Request

The applicant is requesting approval of a COA application to remove three non-functioning wood frame kitchen windows, and replace them with new CGI Estate Aluminum windows with wood grain finish.

**Kitchen windows
to be replaced**

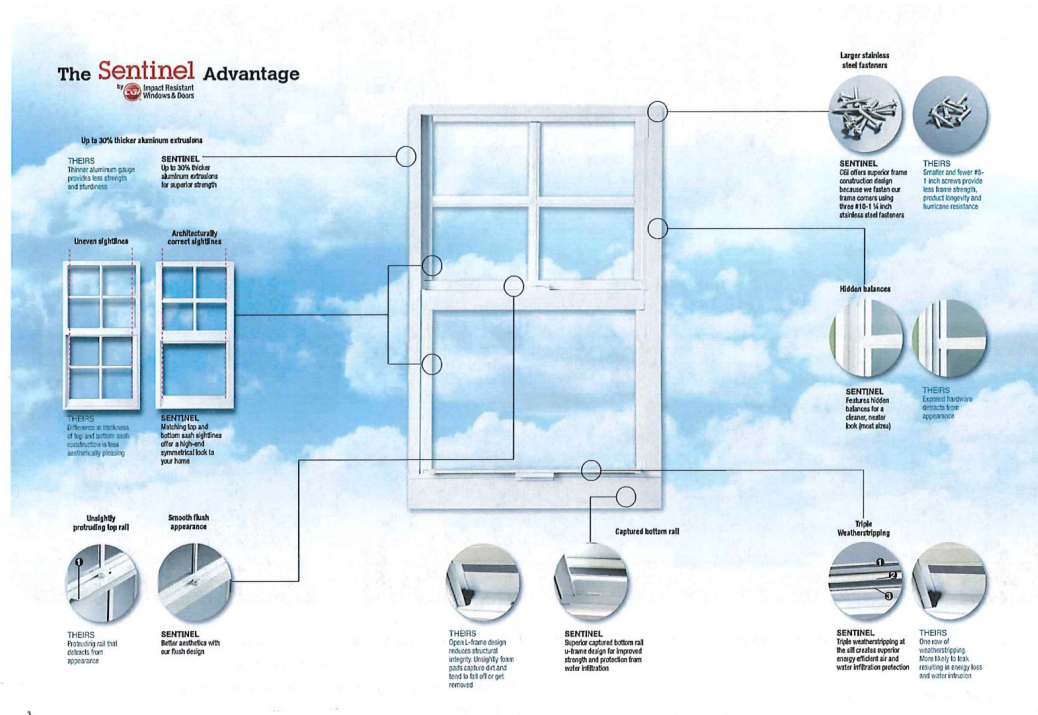
The current proposal seeks to install aluminum windows that are non-compatible with the materials appropriate to protect the historic integrity of the residence. Based upon Secretary of Interior Standards 2, 5 and 6, staff recommends that the Board approve the request for installation of three new windows with condition that the windows will be replaced by wooden windows instead of the proposed aluminum.
